GOODWIN UNIVERSITY EDUCATIONAL SERVICES, INC.
Special Meeting of the School Building Committee
December 09, 2025 at 12:00 pm

Goodwin University
Magnet Technical High School
State Project #542-0007 MAG/N

Subject: Progress Report

Total GMP Change Order #5

PARTIAL FIRST FLOOR PLAN
Scale: 1/8"=1'-0", Reference: 1 / A1.11

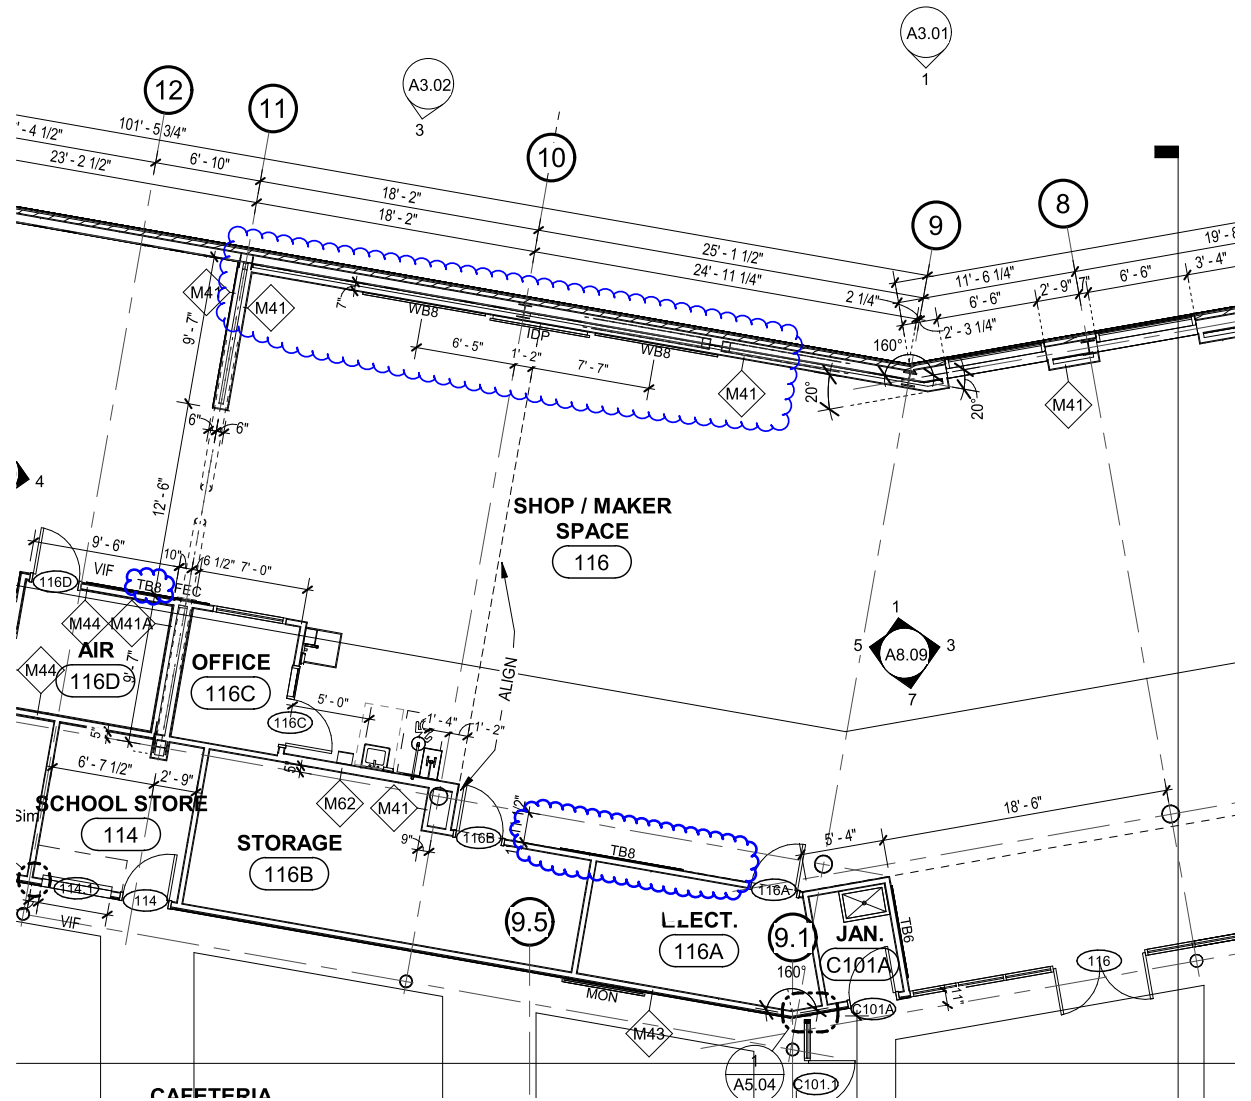
- EXTEND M41 WALL TO GRID LINE 11 AND REVISE LOCATION.
- RELOCATE (1) WB8 AND (1) TB8
- ADD (1) WB8
- ADD (1) IDP
- OMIT BUTCHER BLOCK TOP ON SOUTH WALL.
- REFER TO TECHNOLOGY AND MEP SKETCHES.

<div>B A</div>	BEMIS ASSOCIATES, LLC	JOB NAME / NUMBER: GOODWIN INDUSTRY 5.0 HIGH SCHOOL		TITLE: ELECTRIC ROOM 116A REVISION	DRAWING NO: SKE-06
	Consulting Engineer	SCALE: 1/4" = 1'-0"			
	185 Main Street Farmington, CT 06032 (860) 667-3232 x111 Fax: (860) 323-7070	DATE: 07/24/2025	PREPARED BY: PFP

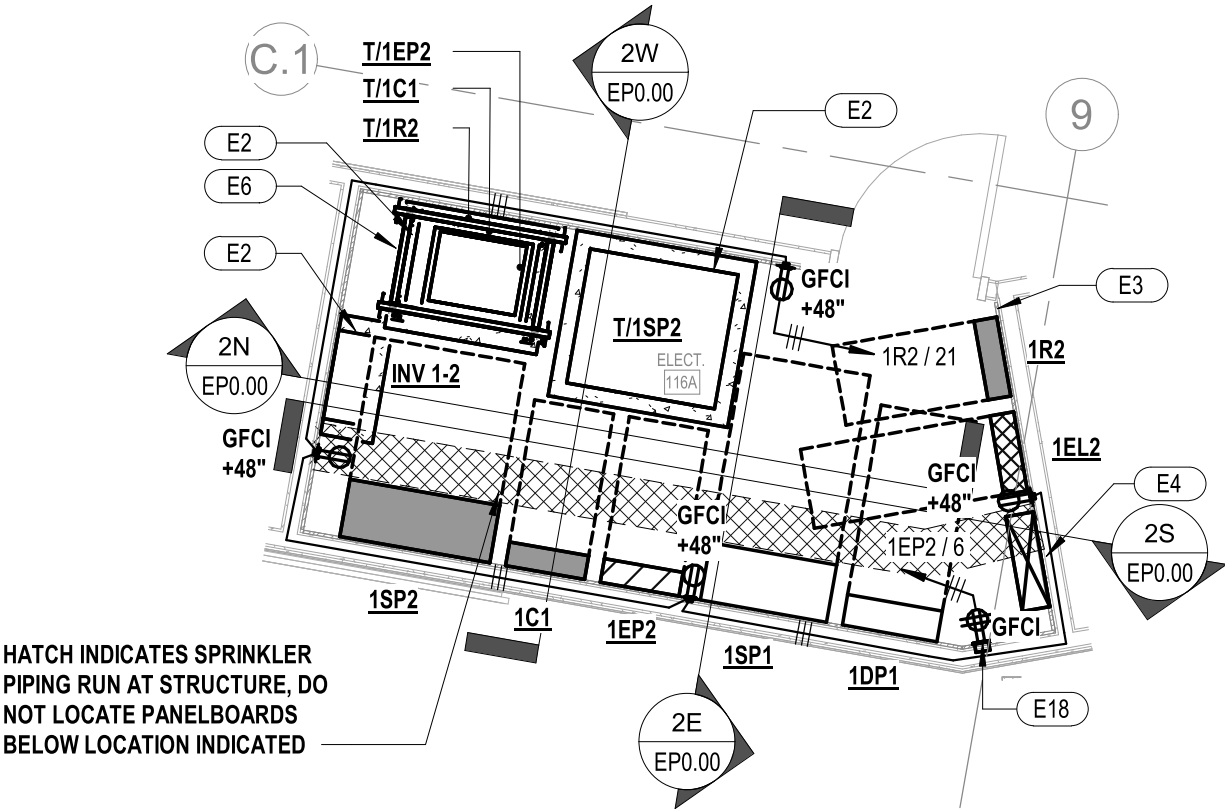
CONVENIENCE POWER - KEYED NOTES	
KEY	REMARKS
E15	DIGITAL DELAY, E.G. SMALL FURNISH & REFILL (2) DUPLEX RECEIPT PLACES IN AN WALL BOX (FURNISHED & INSTALLED BY A/C CONTRACTOR). RECEIPT PLACES SHALL BE LOCATED IN TOP OF BOX.
E16	QUAD RECEIPT PLACES MOUNTED IN PILEUM ENCLOSURE IN CEILING BY TECHNOLOGY CONTRACTOR (VERIFY EXACT LOCATION WITH TECHNOLOGY CONTRACTOR PRIOR TO DESIGN).

T1.11

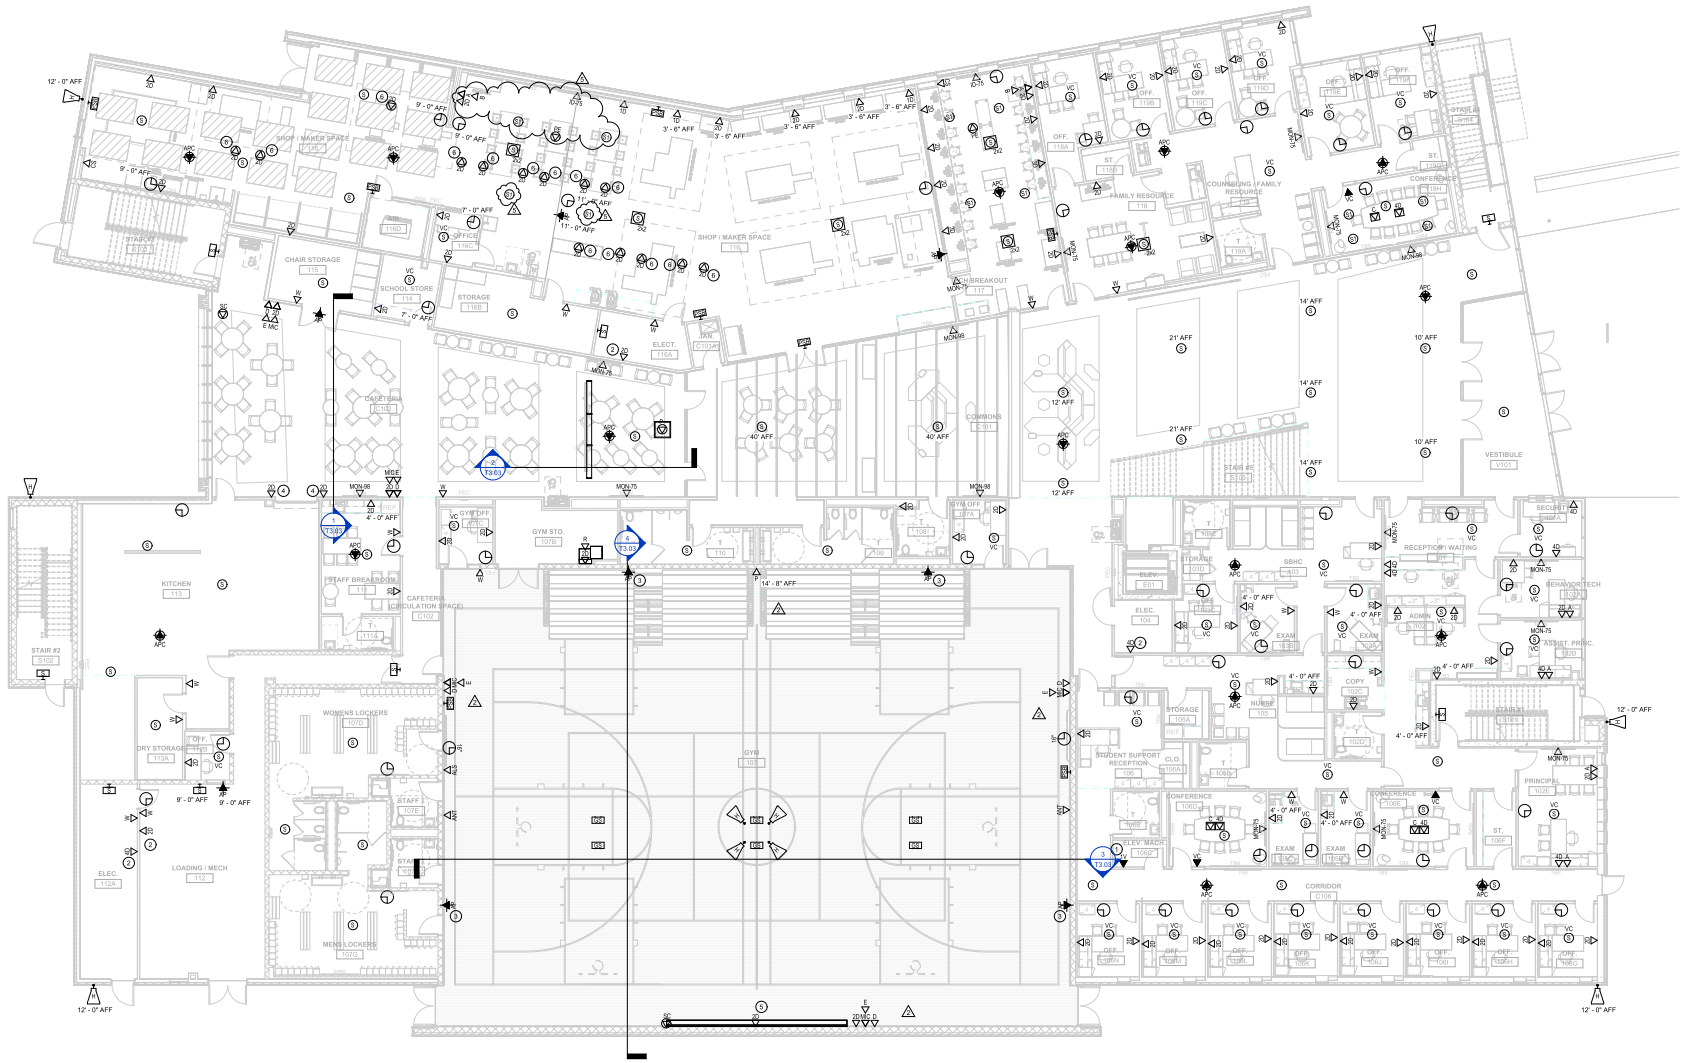
- Shop Maker Space #116:
 - Add classroom AV system, including:
 - ID-75 infrastructure
 - A, B, & 2D devices
 - QTY (4) S1 ceiling speakers
 - PE plenum enclosure

PARTIAL FIRST FLOOR PLAN
Scale: 1/8"=1'-0", Reference: 1 / A1.11

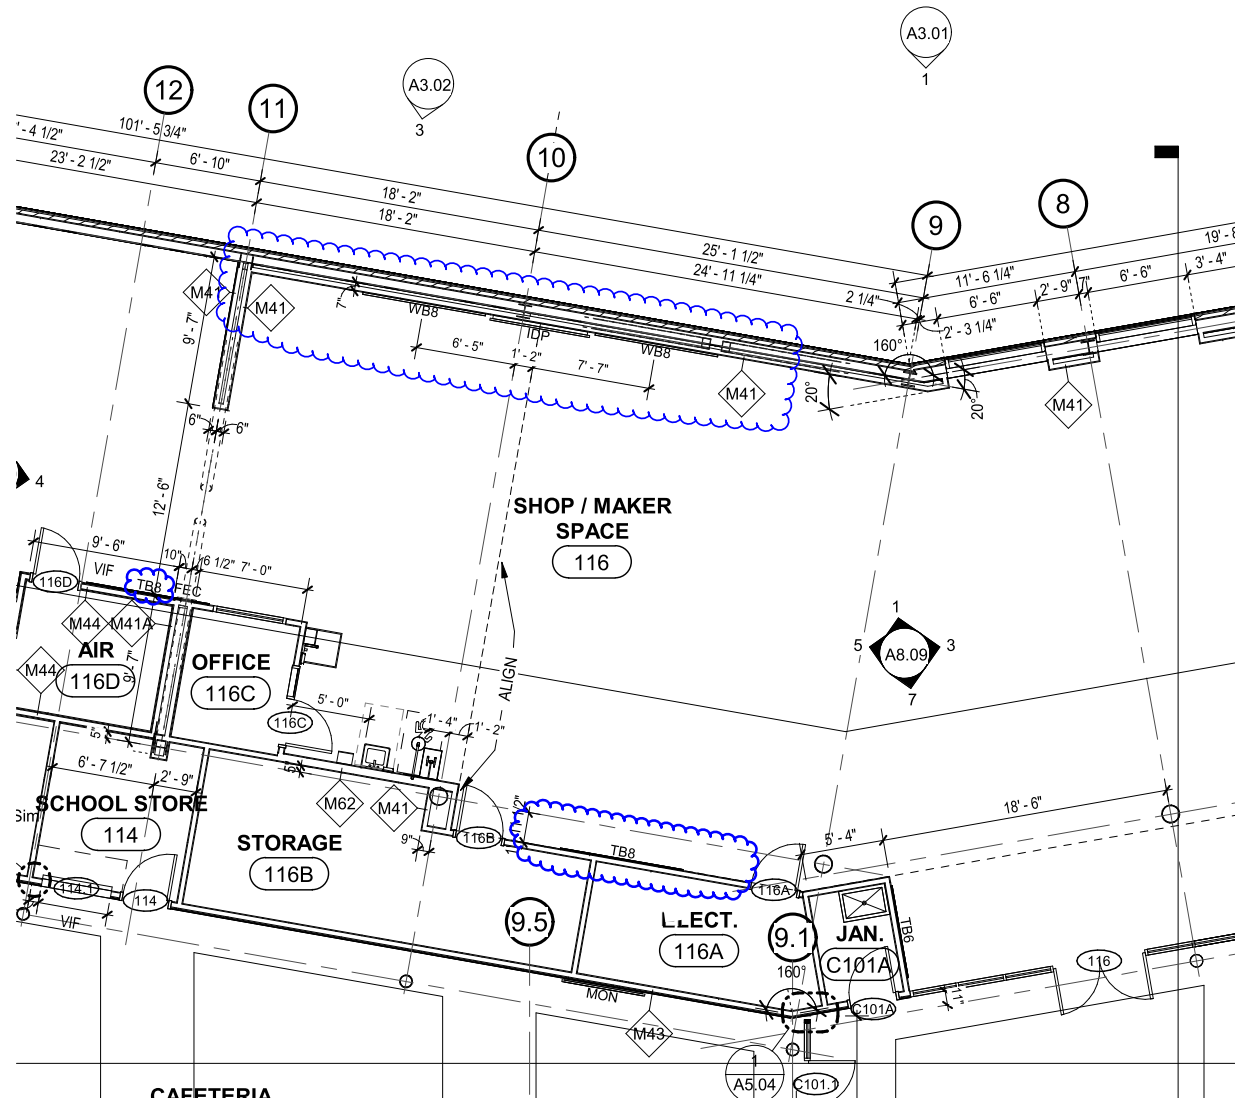
- EXTEND M41 WALL TO GRID LINE 11 AND REVISE LOCATION.
- RELOCATE (1) WB8 AND (1) TB8
- ADD (1) WB8
- ADD (1) IDP
- OMIT BUTCHER BLOCK TOP ON SOUTH WALL.
- REFER TO TECHNOLOGY AND MEP SKETCHES.

T1.11

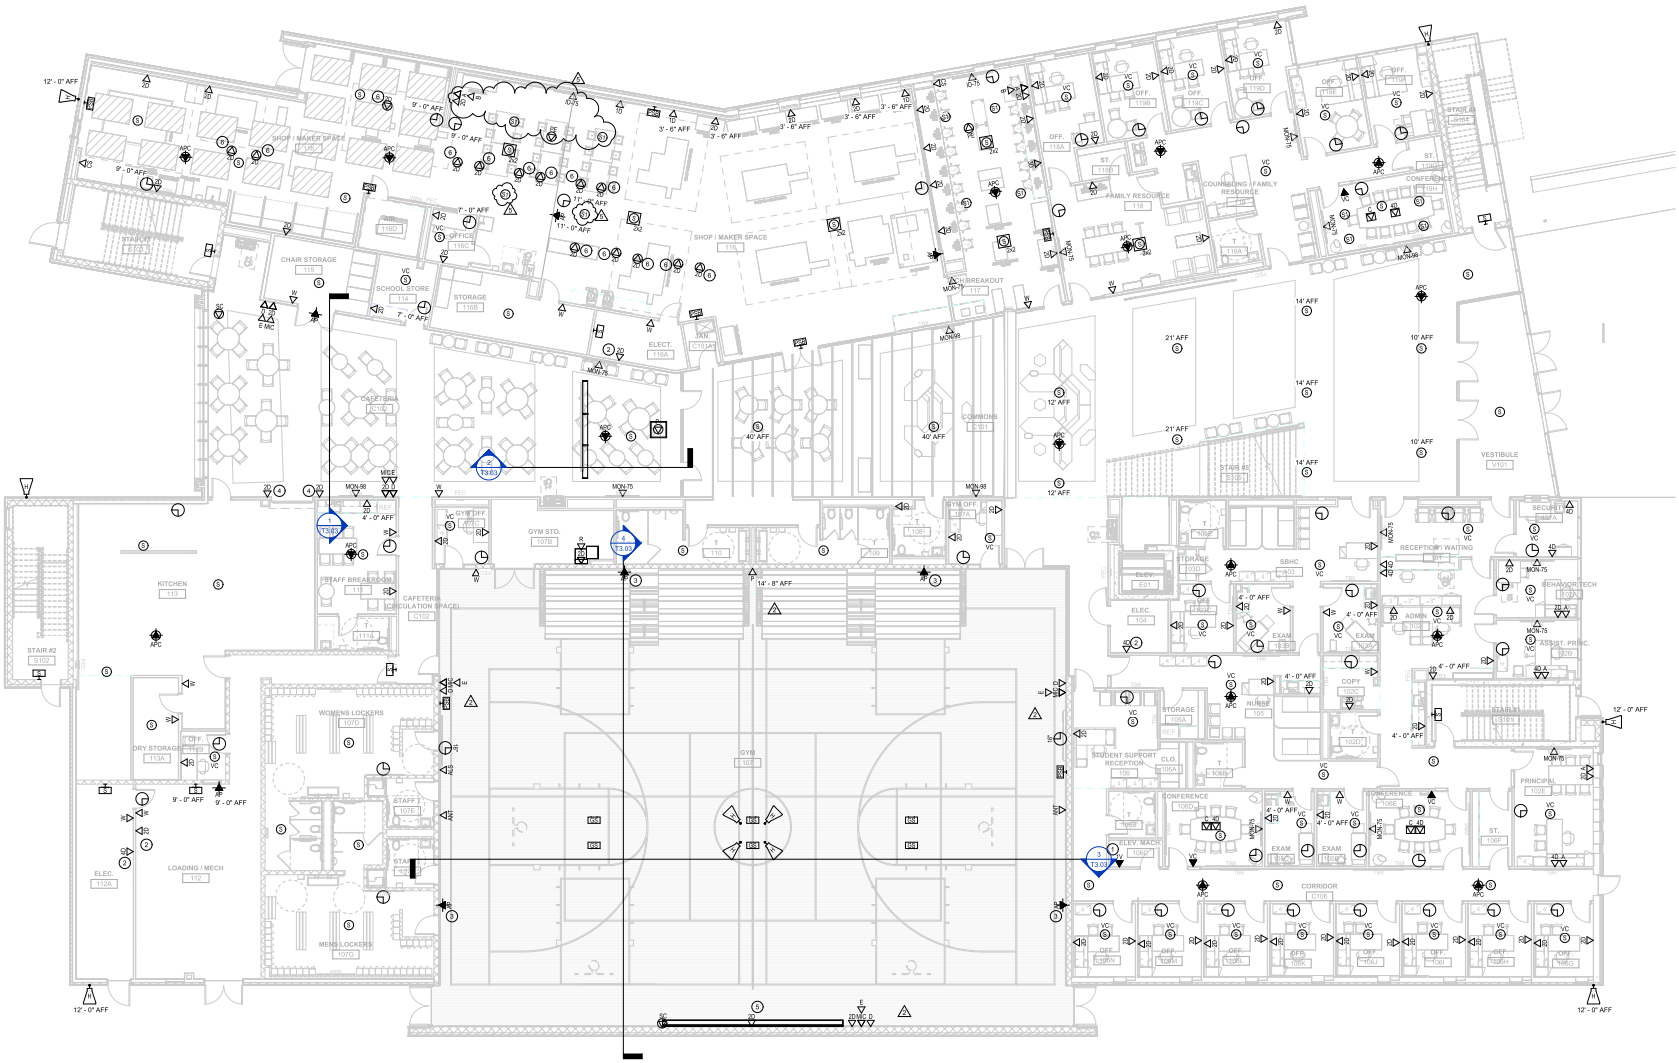
- Shop Maker Space #116:
 - Add classroom AV system, including:
 - ID-75 infrastructure
 - A, B, & 2D devices
 - QTY (4) S1 ceiling speakers
 - PE plenum enclosure
